Location Address: 1700 North SR 7

Explanation of Request: DEMOLISH EXISTING BUILDING AND CONSTRUCT A NEW RETAIL BUILDING AND PARKING LOT

RE: **Site Plan Review for a 4,000 sq. ft. commercial building (Al's Florist)**
File # 19-DP-27
SMA Project No. 2017-186

1
A3.0
EAST ELEVATION
1/8" = 1'-0"

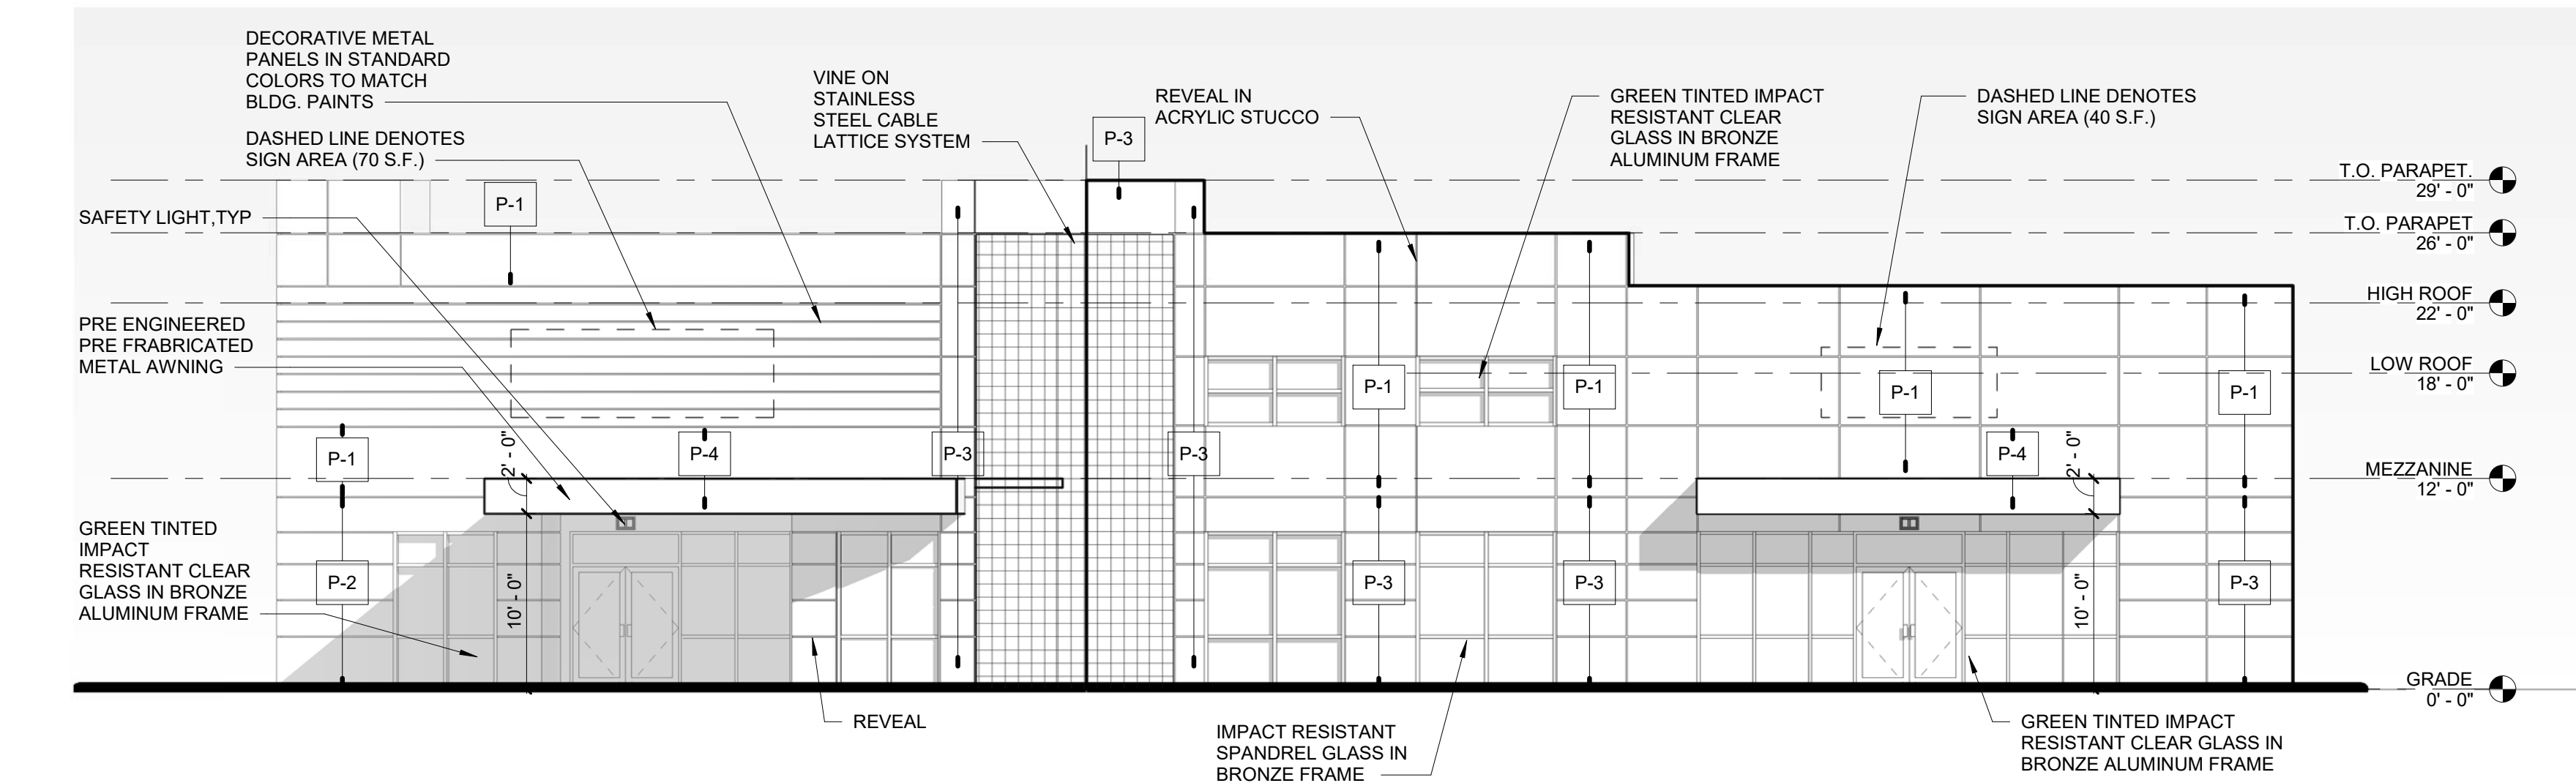
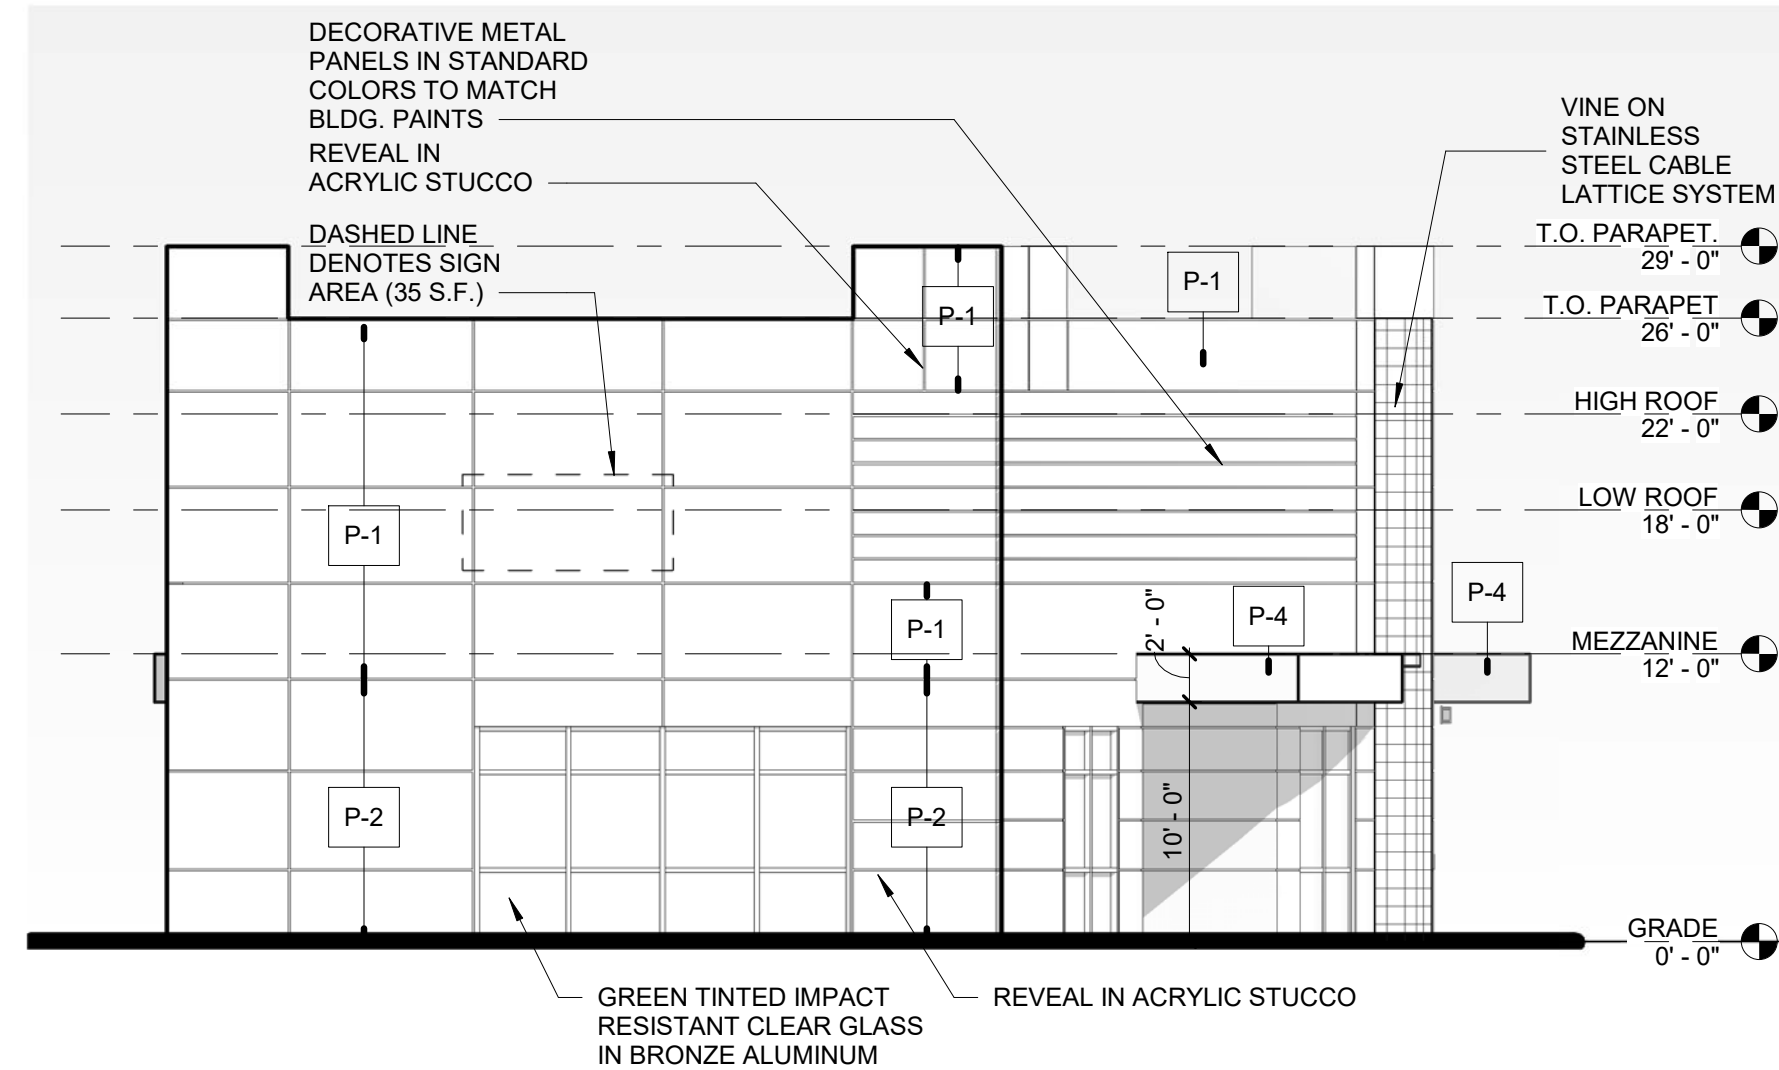
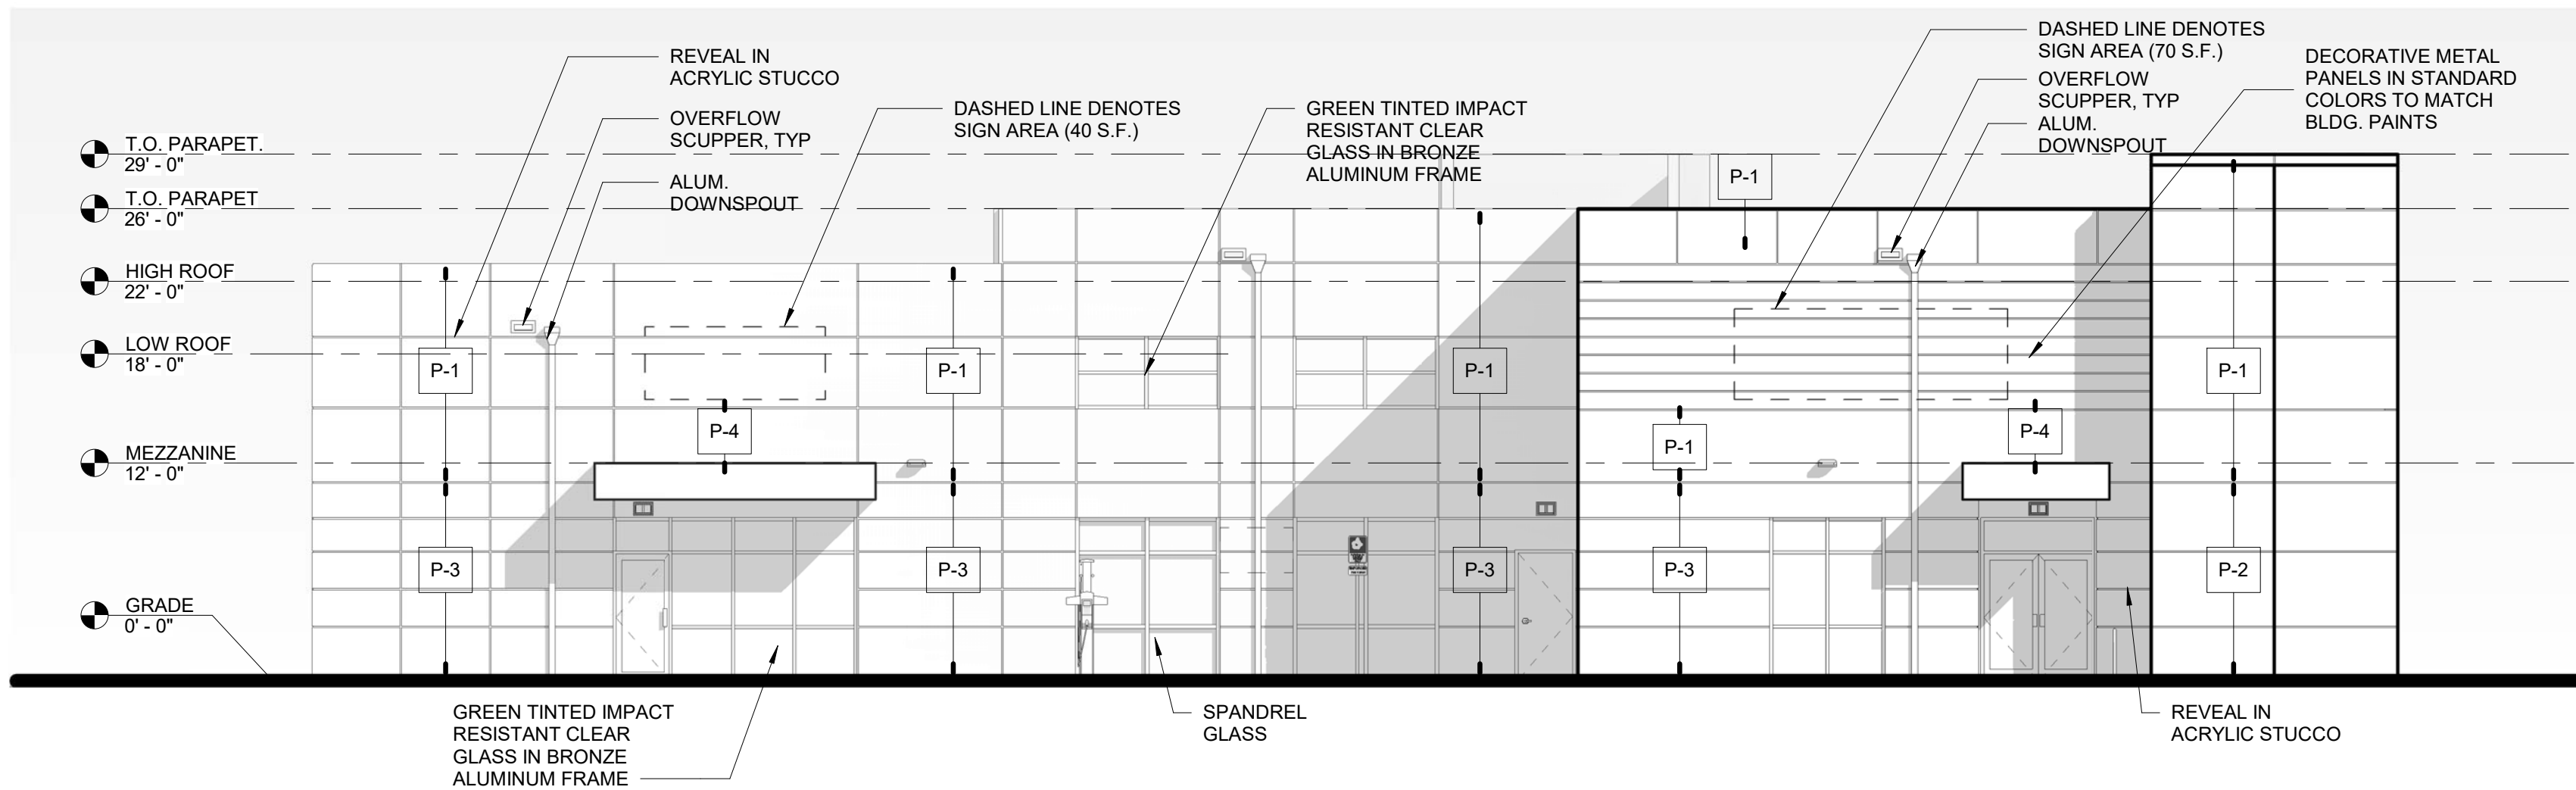
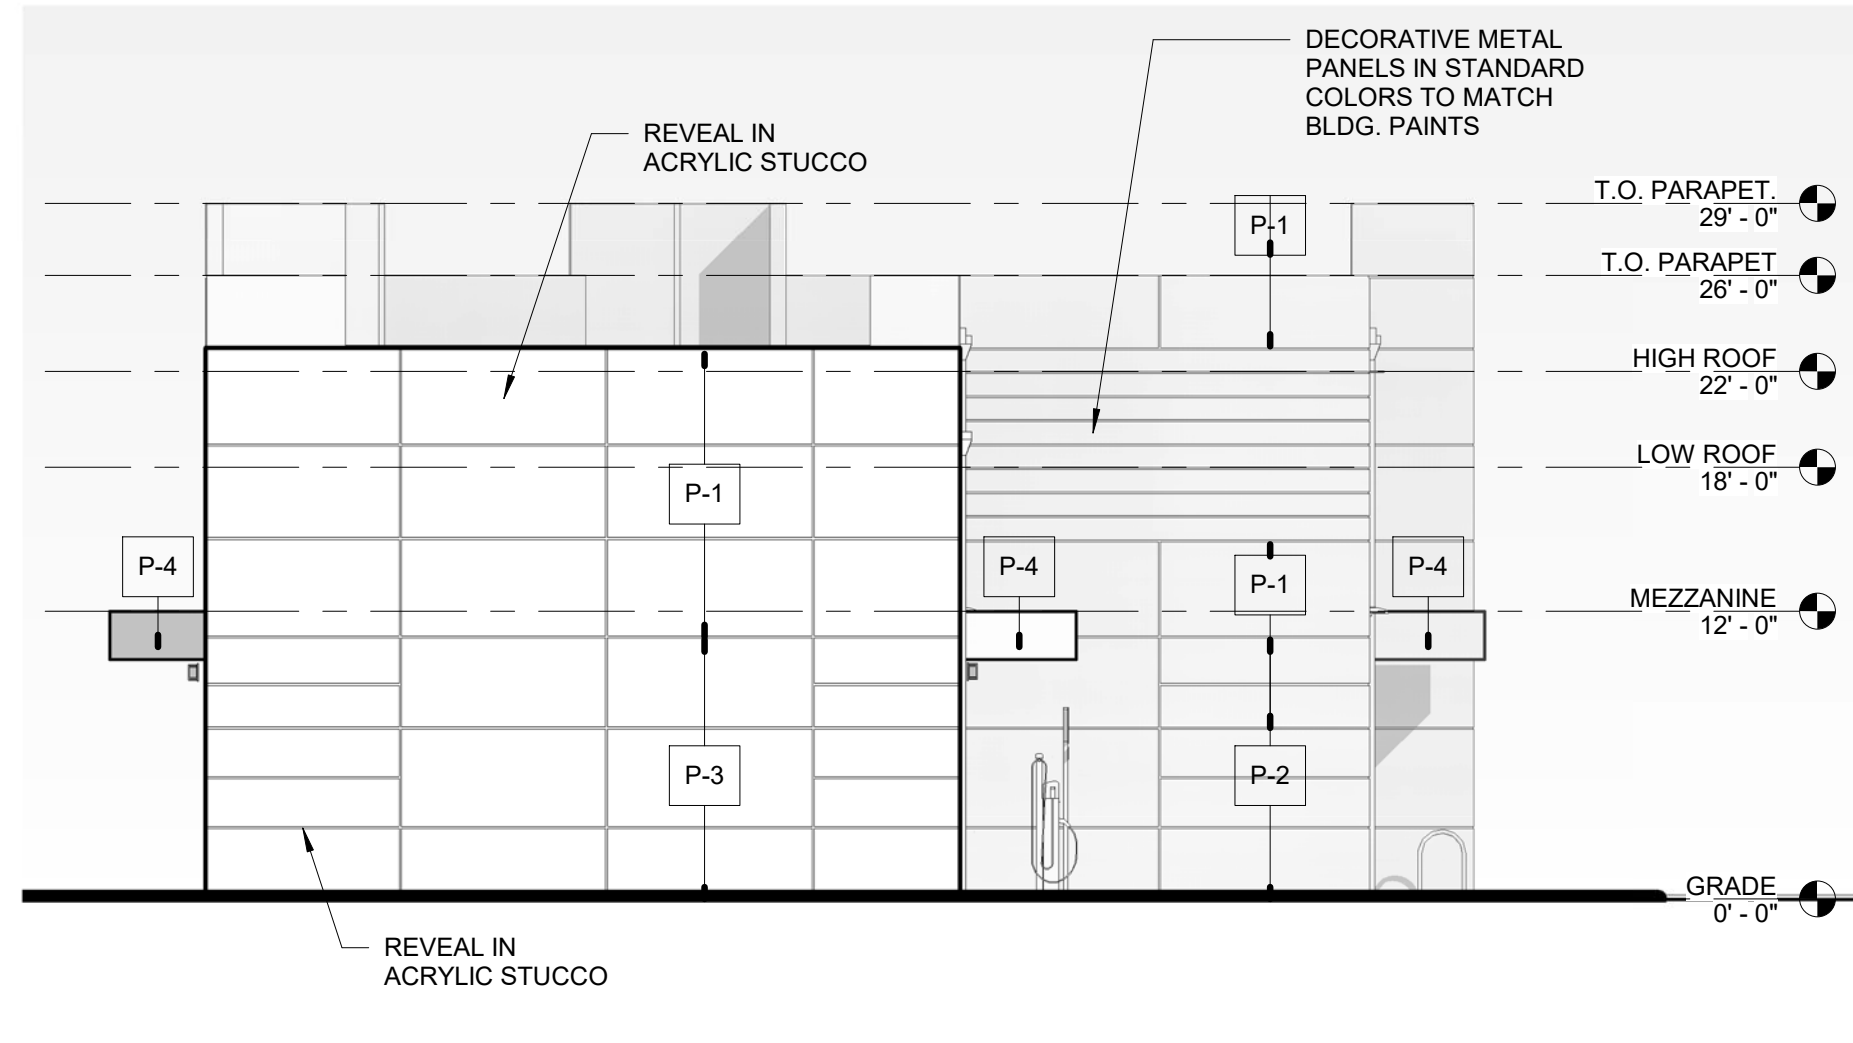
9. Comment: Work with Public Works and Engineering Division to ensure adequate and safe access is provided for garbage truck to access garbage and recycling area.
Response: *Please refer to revised entry driveway, updated per meeting with Engineering, on sheet SP1.0.*
10. Comment: Building height shall be measured to the top of the roof slab. Revise elevations accordingly to show building height and height of projections above.
Response: *Revised as requested. Please refer to sheet A3.0.*

ALL SIGNAGE SHALL BE IN COMPLIANCE WITH THE ZONING AND LAND DEVELOPMENT REGULATIONS.
